PEACH BOTTOM ATOMIC POWER STATION, UNIT NO. 2

AMENDMENT TO FACILITY OPERATING LICENSE

Amendment No. 86  
License No. DPR-44

SAFETY EVALUATION BY THE OFFICE OF NUCLEAR REACTOR REGULATION  
SUPPORTING AMENDMENT NO. 86 TO FACILITY OPERATING LICENSE NO. DPR-44

FIGURE 3.5.1.K Maximum Average Planar Linear Heat Generation Rate Versus Planar Average Exposure

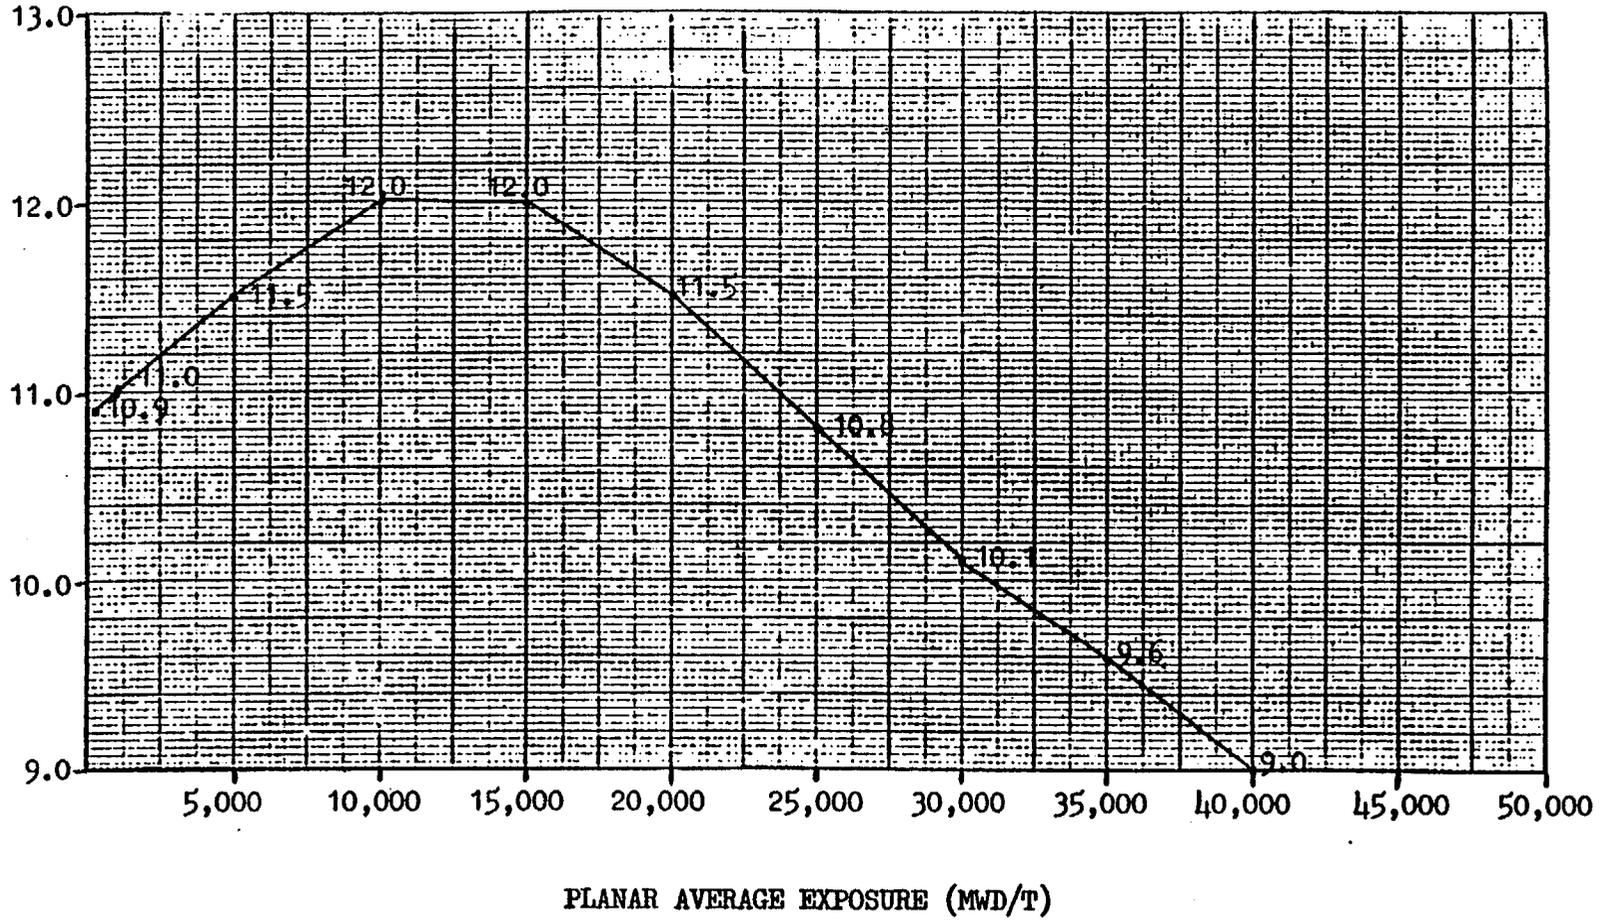
The licensee has proposed the addition of a generic P8x8R MAPLHGR curve to the plant Technical Specifications. This curve would be added for the purpose of reducing the need for future cycle-dependent revisions to the Technical Specifications. It was constructed to bound the Reload 4 and Reload 5 P8x8R fuel at Peach Bottom Unit 2. Because this curve was generated from a number of specific fuel types, rather than from the set of all possible P8x8R fuel loadings, it is necessary that the licensee determine that the generic P8x8R MAPLHGR curve is

bounding for future specific MAPLHGR limits supplied by the fuel vendor (e.g. General Electric). Should this be the case, we would accept use of the generic MAPLHGR curve without additional modification to the plant Technical Specifications.
